16710/P008259  
Serial: H1-1304066  
December 5, 2013

Subj: ISLAND FLYER, O. N. 1131233  
Gold Coast Yachts, Inc. Hull No. GCY65WPCH202  
65' x 24' x 7' Small Passenger Catamaran (T)  
67 Passengers / Exposed Waters  
Revised Stability

Subj: ISLAND FLYER, O. N. 1131233; Revised Stability

ISLAND FLYER  
SCALE; 1/4"=1'  
AUGUST 20th, 2013

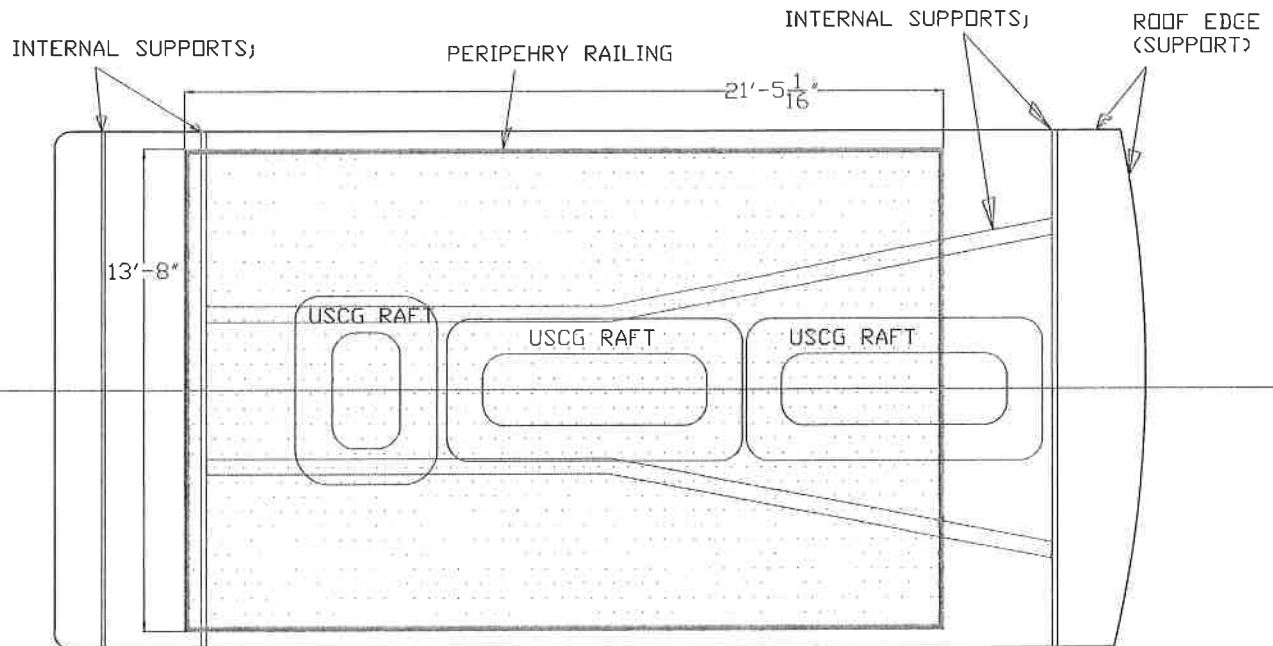
PROPOSED ROOF AREA FOR PASSENGERS; 13'8" x 21'5".
